Subject: QA Program for ST Containers
Docket Number: 71-9246

NRC LETTER ENCLOSURES FOR “ST” CONTAINER PACKAGE:

- (1) NIST PACKAGING AND SHIPPING QUALITY ASSURANCE PROGRAM FOR 10 CFR 71 – TRANSPORT OF RADIOACTIVE MATERIALS**
- (2) TEST DATA & ASSOCIATED CRITICALITY CALCULATIONS FOR THE “ST” CONTAINER**
- (3) “ST” CONTAINER MODIFICATIONS & DESIGN CHANGES**
- (4) SAFETY EVALUATION REPORT FOR “ST” CONTAINER**
- (5) DRAWING D-04-048 (REVISION 4): SHIPPING CONTAINER MODEL “ST” SERIES**

**NIST PACKAGING AND SHIPPING QUALITY
ASSURANCE PROGRAM FOR 10 CFR 71 –
TRANSPORT OF RADIOACTIVE MATERIALS**

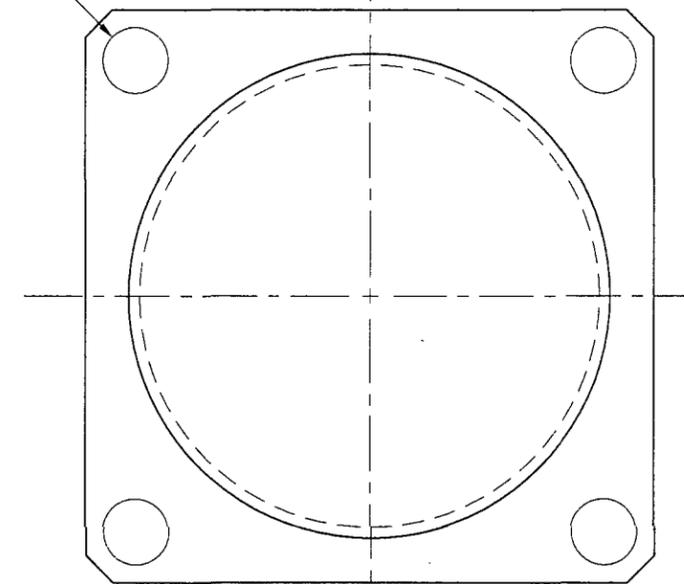
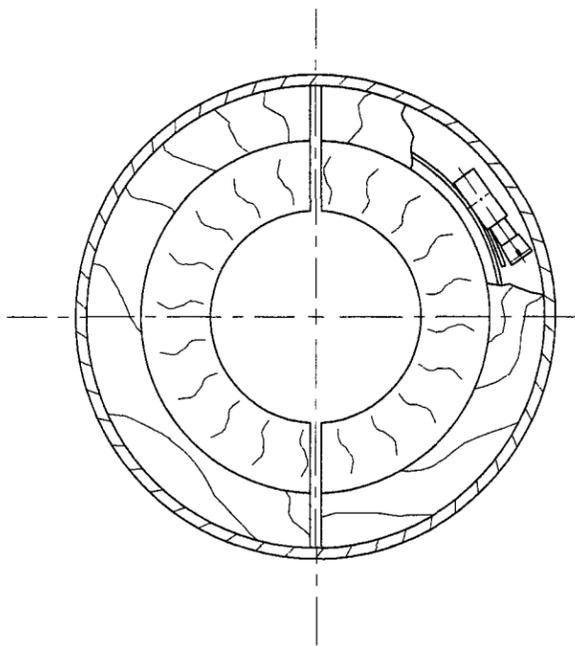
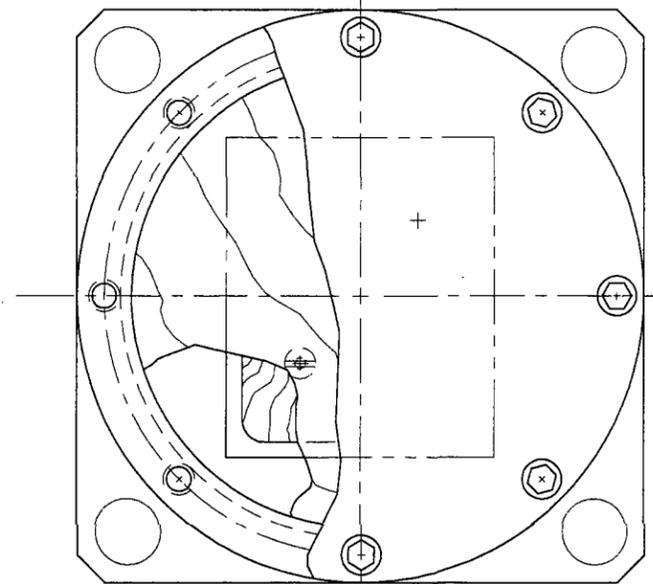
REVISIONS					
NO.	ECN	CHANGE	INCRP. BY:	DATE	CHECKED BY:
1		"AS BUILT"	PJL	2/07/92	MAS
2		PLUGGED 3/4" HOLES BY WELDING IN 3/16" THK. STEEL BLANKS.	PJL	2/18/92	JHN
3		REPLACED WOOD SCREW WITH TEE NUT AND BOLT REDUCED OD OF TOP SUPPORT: 5 3/16 TO 5 1/16 REDUCED OD OF NOZZLE SUPPORT: 5 1/4 TO 5	PJL	5/17/96	MAS
4		CORRECTED "AS BUILT" DIMENSIONS AND ADDED DIMENSIONAL TOLERANCES.	PJL	8/02/07	CCD

DIV: 856
 REVISION NO: 4
 DRAWING NO: D-04-048

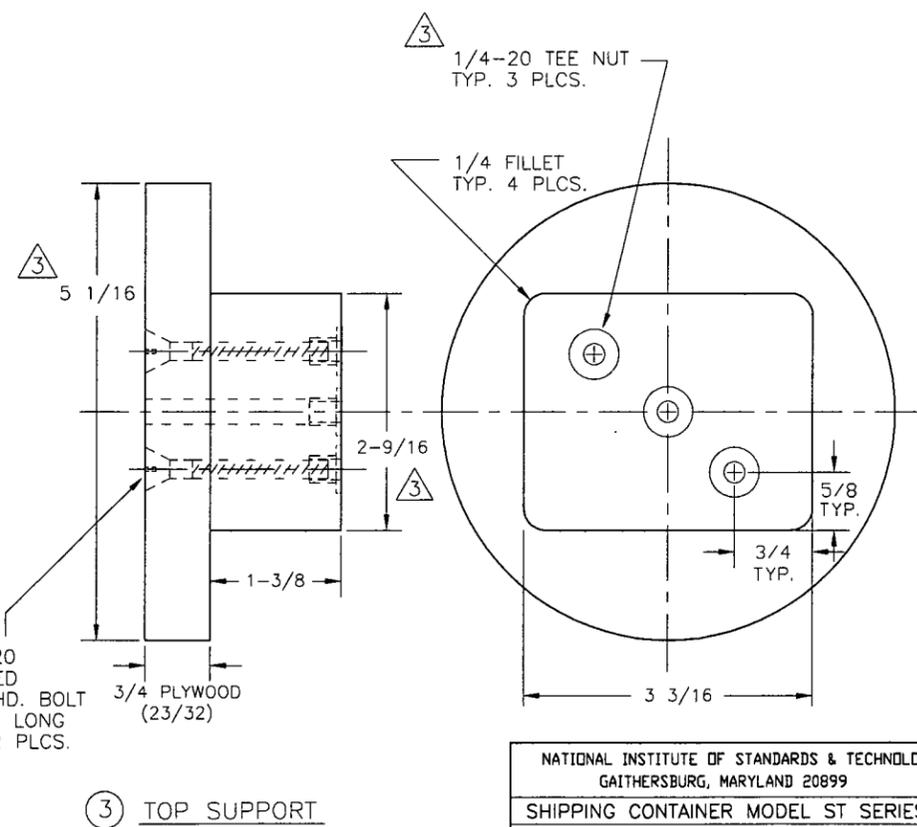
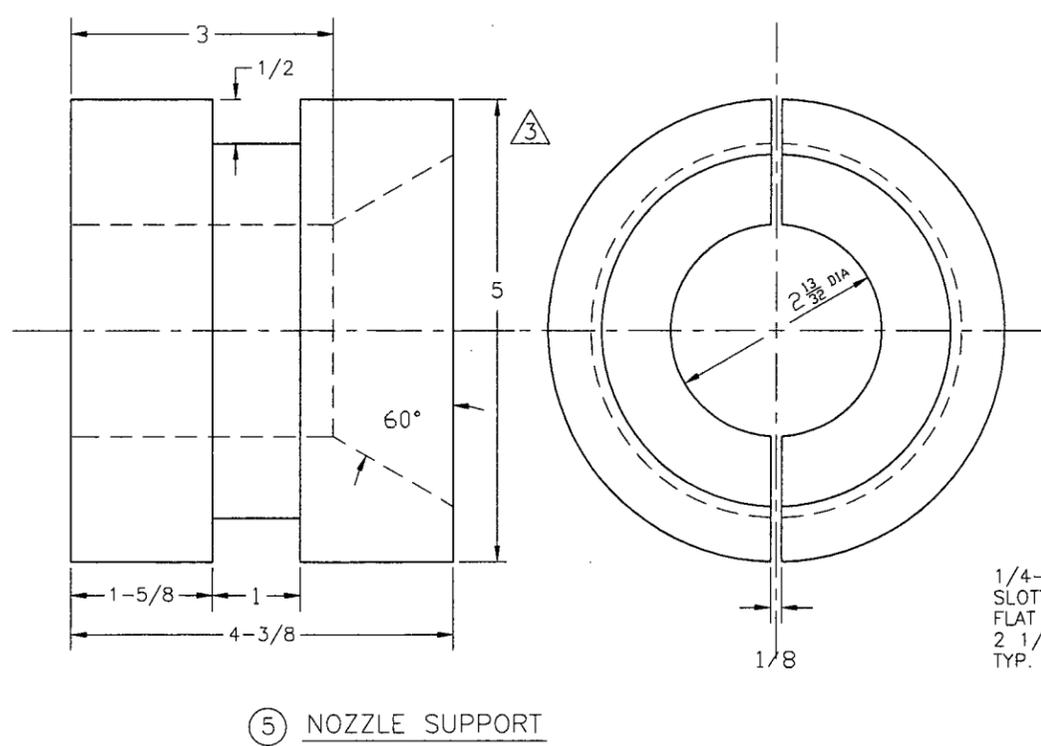
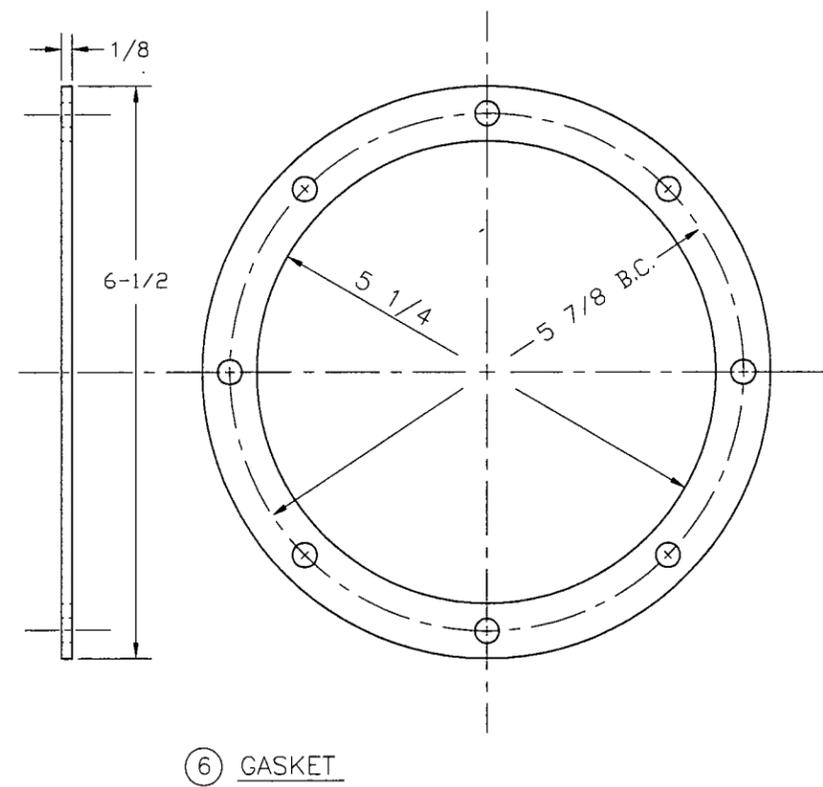
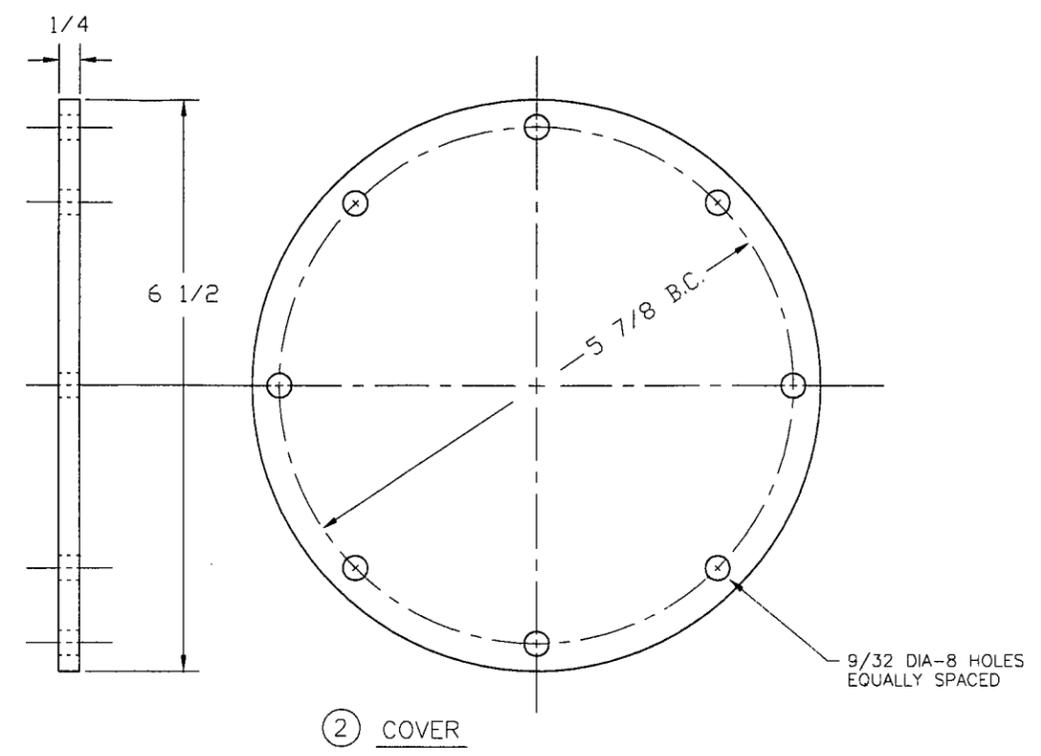
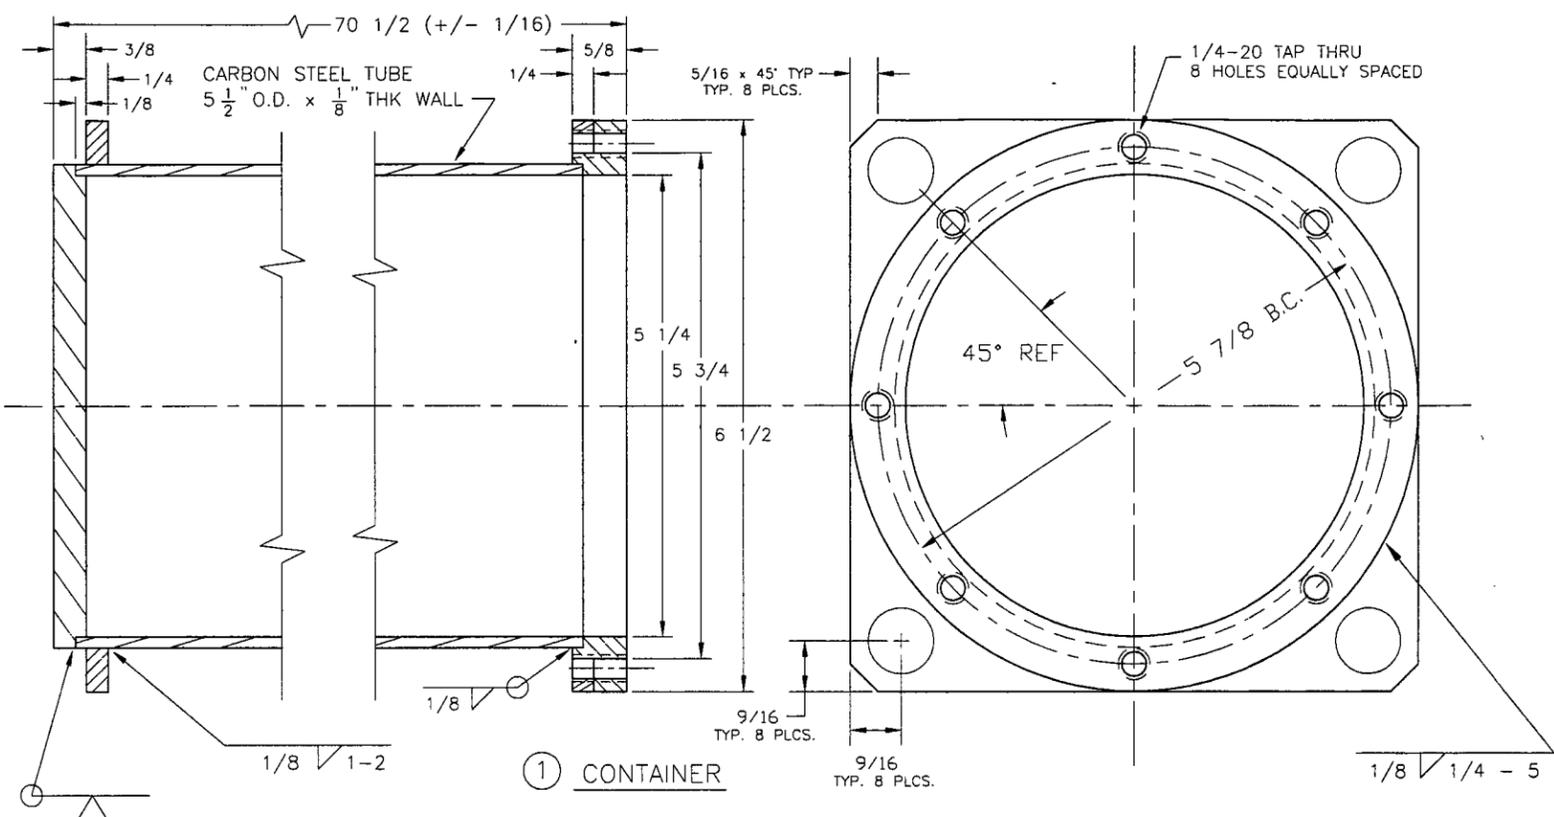
In order to improve handling, assembly and disassembly of the above subject shipping container, the following minor modifications to the wooden supports within the container are proposed (Refer to drawing no. D-04-048, rev. 3):

- (i) Decrease diametrical dimensions by 1/8" of item no. 3, 4, and 5 (Top, Bottom, and Nozzle Supports).
- (ii) Replace 2" long wood screws on item no. 3 (Top Support) with 1/4"-20 bolts and tee nuts.
- (iii) Drill a 1/4" diameter thru hole in the center of item no. 3 (Top Support) and install a 1/4" diameter tee nut at the bottom of the lower piece as shown. This will facilitate to remove the Top Support from the fuel element by inserting a 1/4" diameter threaded rod, threading it into the tee nut and pulling the whole assembly out.

These modifications will provide for easier insertion and removal of the fuel element from the container and will eliminate past difficulties experienced in some removals. At the same time, it will provide a positive and reliable hold on the element within the container. Accordingly, it is our conclusion that the proposed modifications do not change any of the safety considerations of the shipping container.
